SUBJECT: MK-2000 LE REMOTE START/STOP RELAY RETROFIT

#3-I-267

7/26/2002

The following is a typical schematic detailing the wiring.

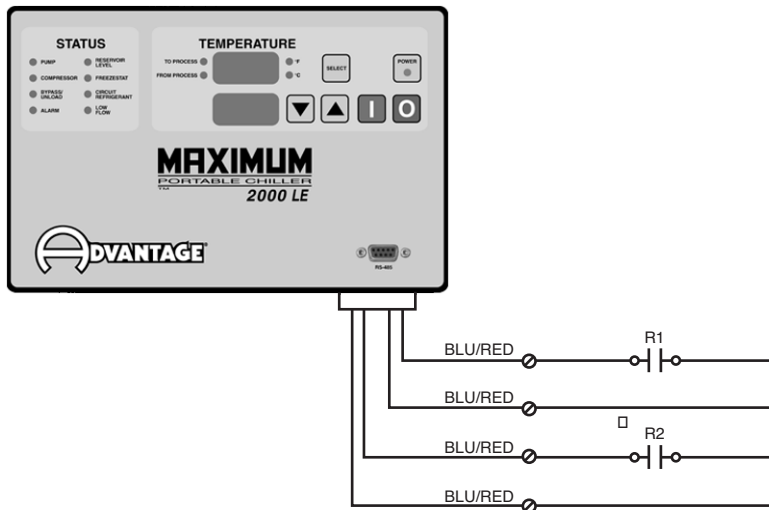
We have discovered electrical interference introduced through the remote start/stop cables has led to instrument damage/failure.

To prevent this occurrence, we recommend the installation of isolation relays to separate the remote start/stop circuit from the remote cables and operators.

Two general purpose relays with 115 volt control coil, and one normally open contact are required.

Start / Stop operators □ must be momentary contact only.
